Q02815

PROPOSAL DRAWING

2022	NAME	SIGN	DATE	TITLE: ALUMINIUM EXTRUSION SQUARE INNER TUBE		
DGN	BRIJESH		17.12.22			
DRN	DEEPAK		17.12.22	MATL. AL- 6061(T6)	TYPE: BOUGHT OUT COMPONENT	
CHD	AMIT		17.12.22		DRG NO. TRIP022-01	SCALE 1 : 1
APPR	ANANT		17.12.22		REF. NO. TRIP022	
		ALL DIMENSIONS ARE IN mm		Unspecified tolerance as per IS 2102:1980 (Medium grade)		REV. NO 01

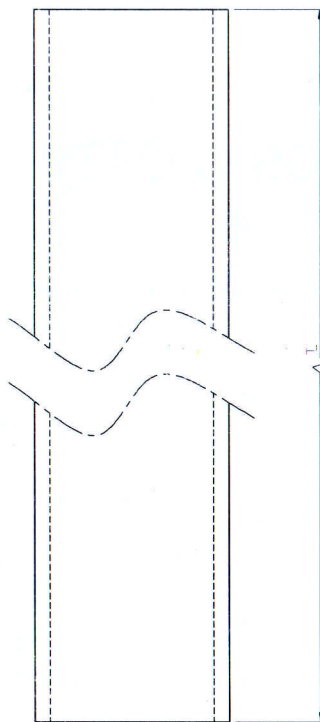
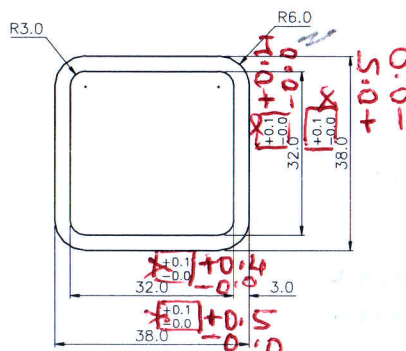
REV. NO.	REVISION DESCRIPTION	REV. DATE
01	CHANGED FROM DIM. 37.5mm(± 0.45) TO 38.0mm($+0.1/-0.0$), 23.5mm(± 0.38) TO 32.0mm($+0.1/-0.0$) AND THICKNESS 7.0mm TO 3.0mm.	17.12.22
